LOCAL PLANNING PANEL AGENDA

Monday 3 May 2021

ITEM 01 DA-275/2020

Item Number:	ITEM 01
Application Number:	DA-275/2020
Proposed Development:	Demolition of existing structures and construction of a multi-dwelling housing development containing 6 x two-storey dwellings and 2 x single-storey dwellings above basement car park and associated strata title subdivision.
Property Address	162 & 164 Longstaff Avenue, Chipping Norton
Legal Description:	Lot 184 & 183 DP 243075
Applicant:	Mr J Rafla
Land Owner:	Mr M A L Abrahaim & Mr M F G Ibrahim
Cost of Works:	\$1,254,000.00
Recommendation:	Refusal
Assessing Officer:	Nabil Alaeddine

Figure 6: Proposed Site Plan and Layout (Source: Rafla Arch, Rev A, 18/10/2019)

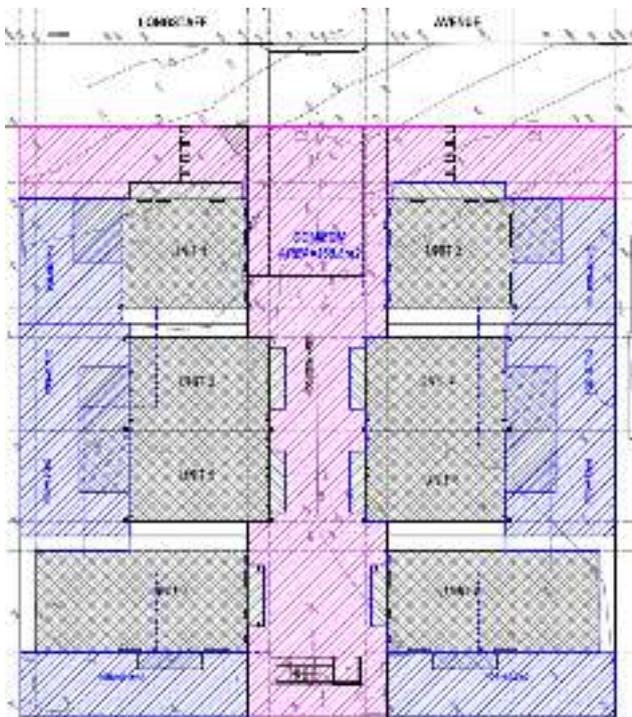
- Units 7 & 8 (single storey dwellings) are located 0.9m from their respective side boundaries. The landscape plan indicates openings in the side walls and Council's Development Control Plan states any windows to habitable rooms on the ground floor requires a 4.0m setback.

- The landscape plan indicates five (5) large Water Gum (*Tristanopsis laurina*) trees that grow to 12m high to be planted along the rear setback. The neighbouring properties to the rear have a drainage easement that runs along the boundary which services the neighbourhood and the proposed species of tree is likely to impact the operation of the easement and therefore is not supported.

Comments: The front setbacks of unit 1 & 2 for the first floor is 3.5m with balcony encroachment which does not comply to Council's Development Control Plan. Side setbacks for units 1 to 6 varies from 3.2m to 3.6m taken from the ground floor alfresco. The alfresco is a structure attached to the dwellings at the rear and includes a roof which reduces the overall setback of the proposal. This is also impacting the rear landscaped and PoS which becomes non-compliant in dimensions.

Figure 7: Proposed Basement Layout (Source: Rafia Arch, Rev A, 18/10/2019)

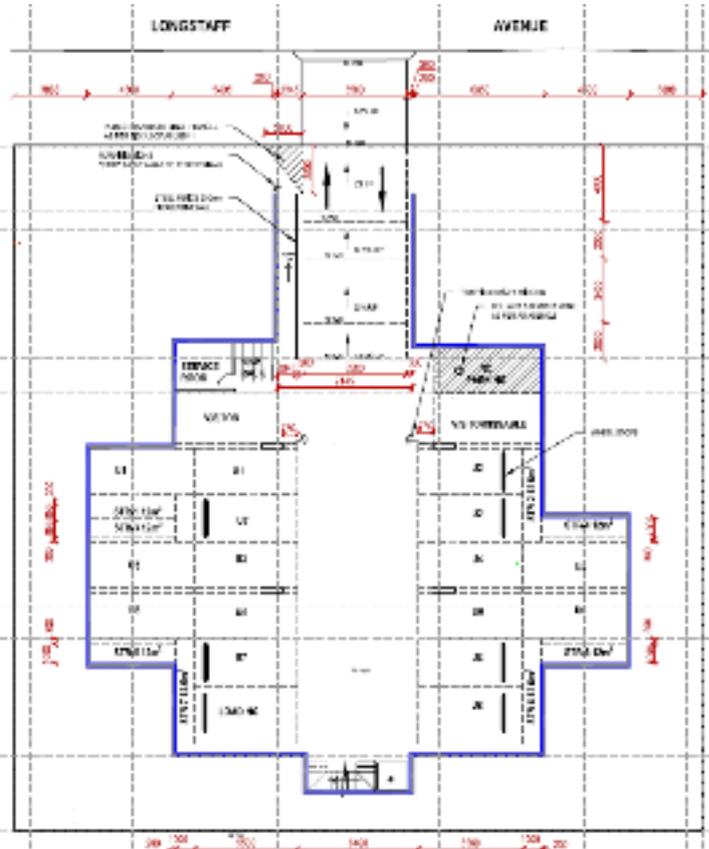
Comments: Basement parking plans accompany the proposal and have been posted online during the notification period.

SHADOW DIAGRAM PLAN

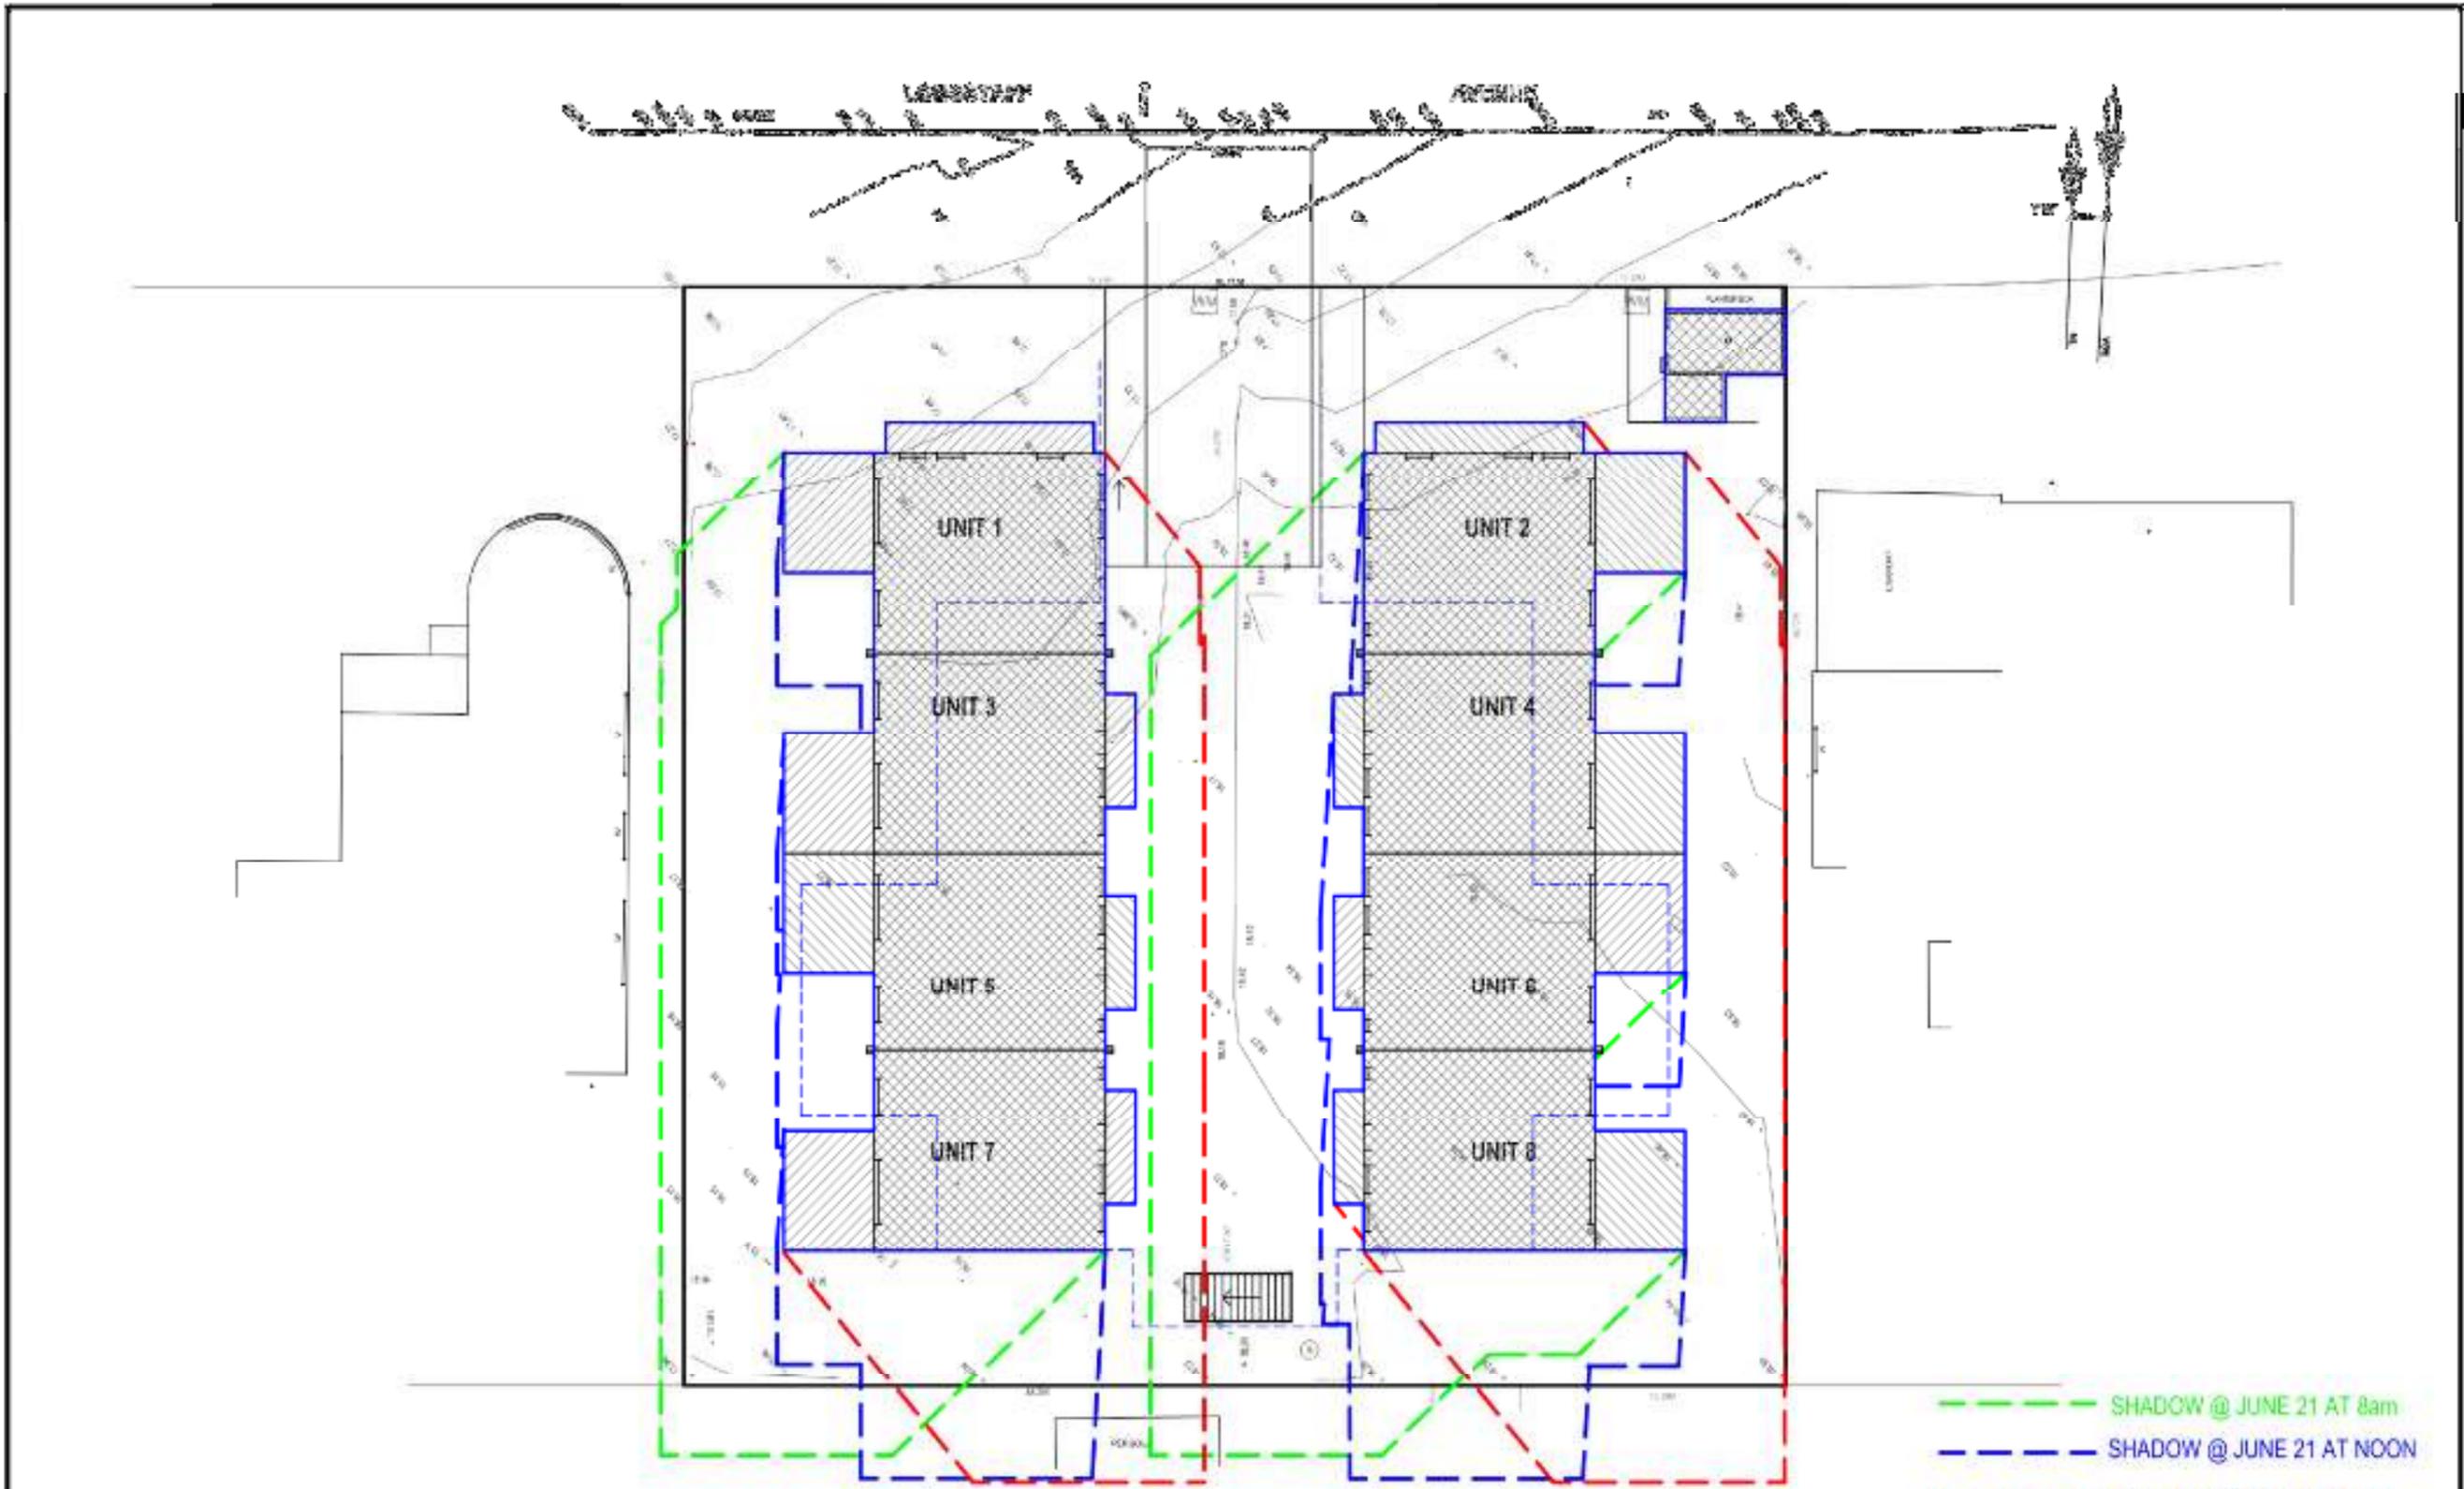
Comment: The amended scheme is unlikely to generate any unreasonable impacts in terms of overshadowing on adjoining properties in accordance with the provisions of Council's Development Control Plan.

The shadow diagrams submitted with the application indicate the proposed development will not prevent any adjoining sites from receiving the minimum required 3 hours of solar access between 9am and 5pm in mid-winter to a living room window on any adjoining property and to at least 50% of the private open space of an adjoining site. However, the proposal will impact on the solar access to the rear single storey lots as unit 5 & 6 are two storey and will overshadow the living areas of units 7 & 8, therefore the proposal is not consistent with Council's Development Control Plan. Furthermore, the applicant has also demonstrated that solar panels on residential dwellings adjacent to the site to south will receive a minimum of 5 hours solar access. In this regard, the development is not considered to provide an unreasonable impact to the immediate locality by way of impacts to solar access and it is consistent of character of a medium density environment.
